Patentees: James George Allen et al  
Patent No. 7,093,544 B1  
Issued: January 6, 2004 September 29, 2006  
Title: Control Device For A Railroad Car

REQUEST FOR A CERTIFICATE OF CORRECTION

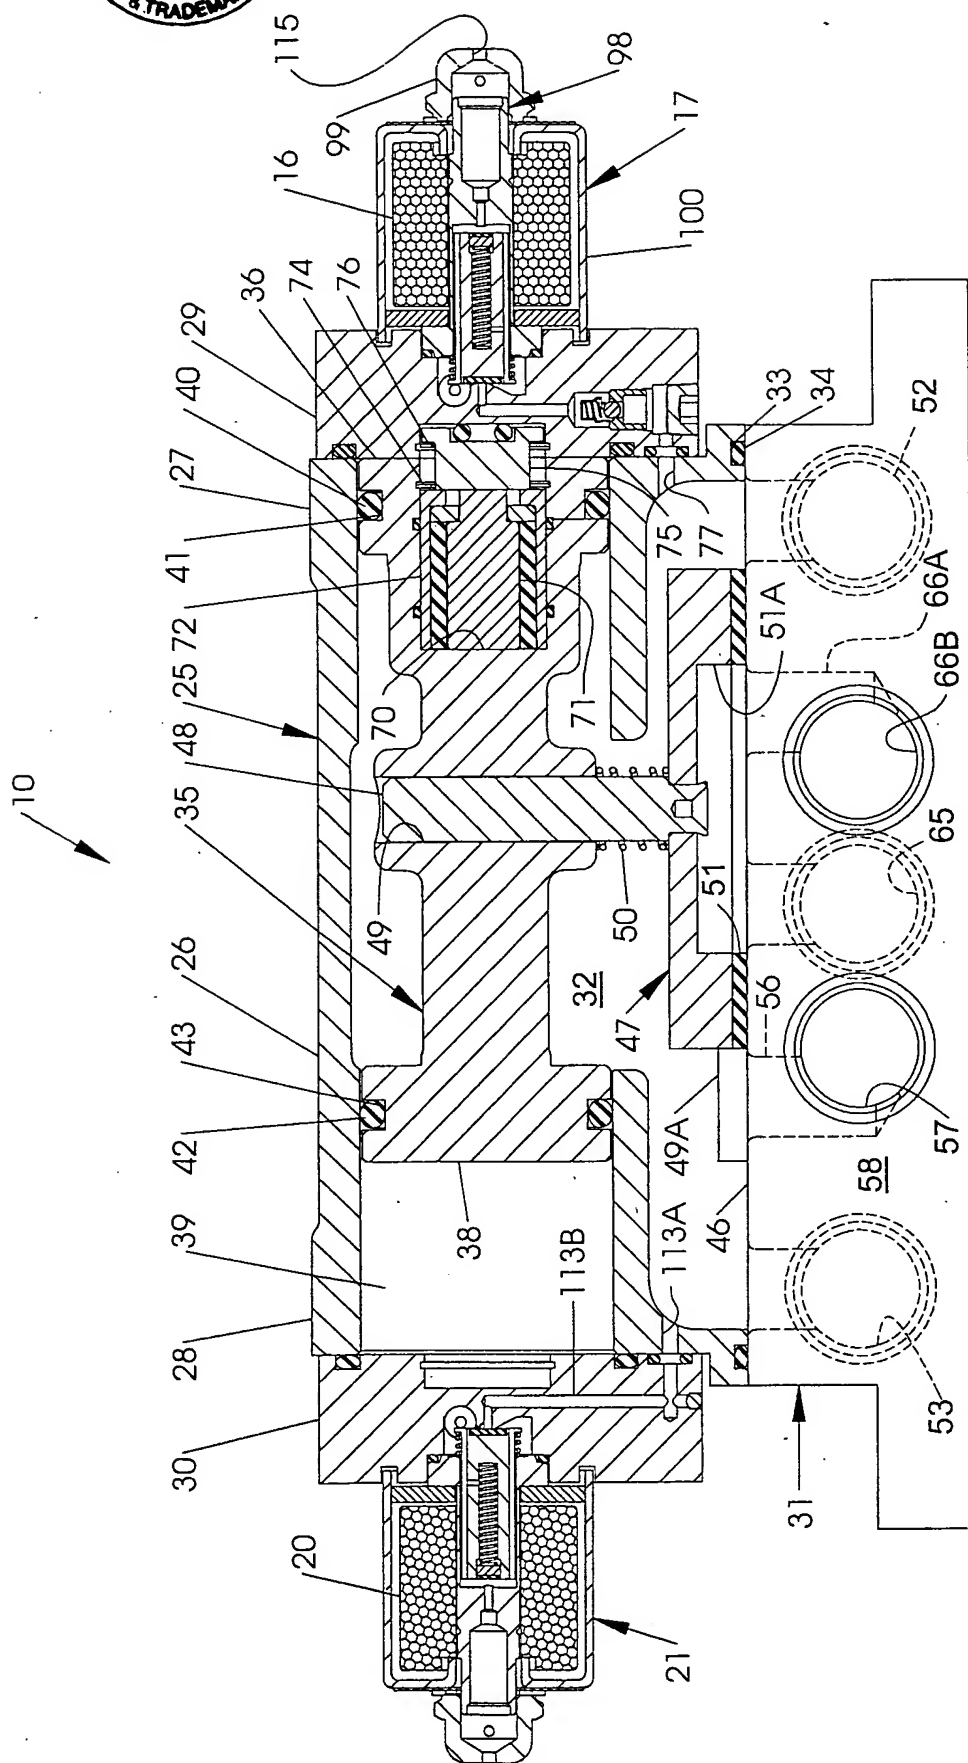
The error in FIG. 1 is that it did not show passages 113A and 113B communicating as described in column 6, lines 54-57 (page 16, lines 10-13 of the application) and as shown in original FIG. 9 but not numbered. These numbers have been added to new FIG. 9. This is not new matter in view of both original FIG. 9 and the specification disclosing this communication.

Delete FIGS. 1, 8, and 9 and substitute included FIGS. 1, 8, and 9

FIG. 8

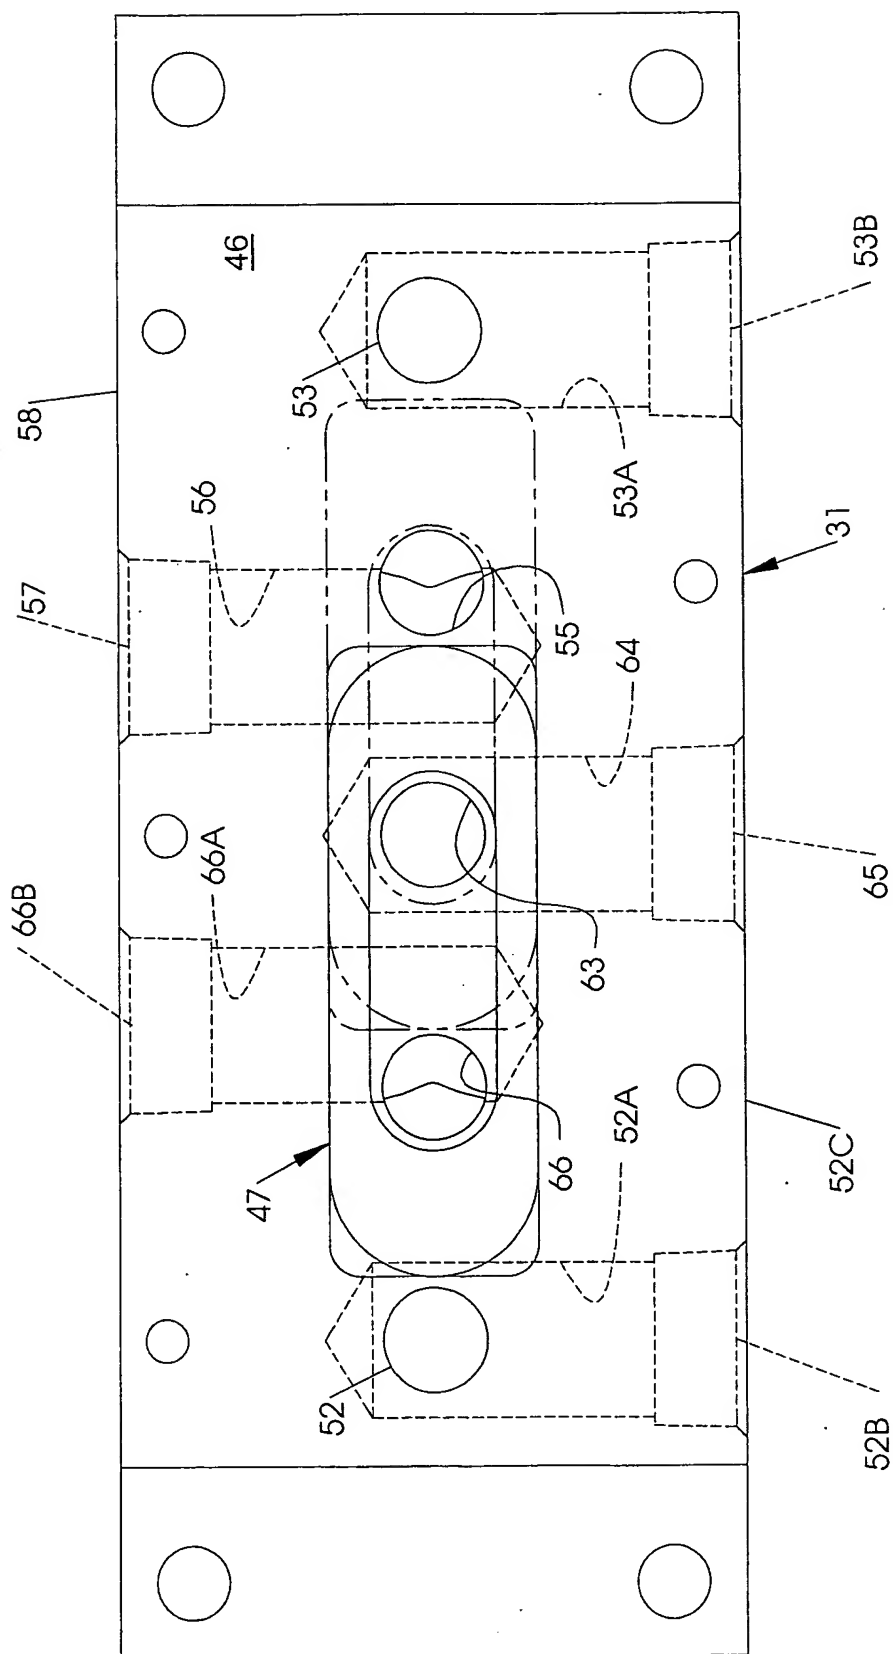
Corrected FIG. 8 adds 53A to identify a passage in plate 31 as described in column 4, line 39 (page 10, line 24 of the application) and as shown in original FIG. 9. This is not new matter.
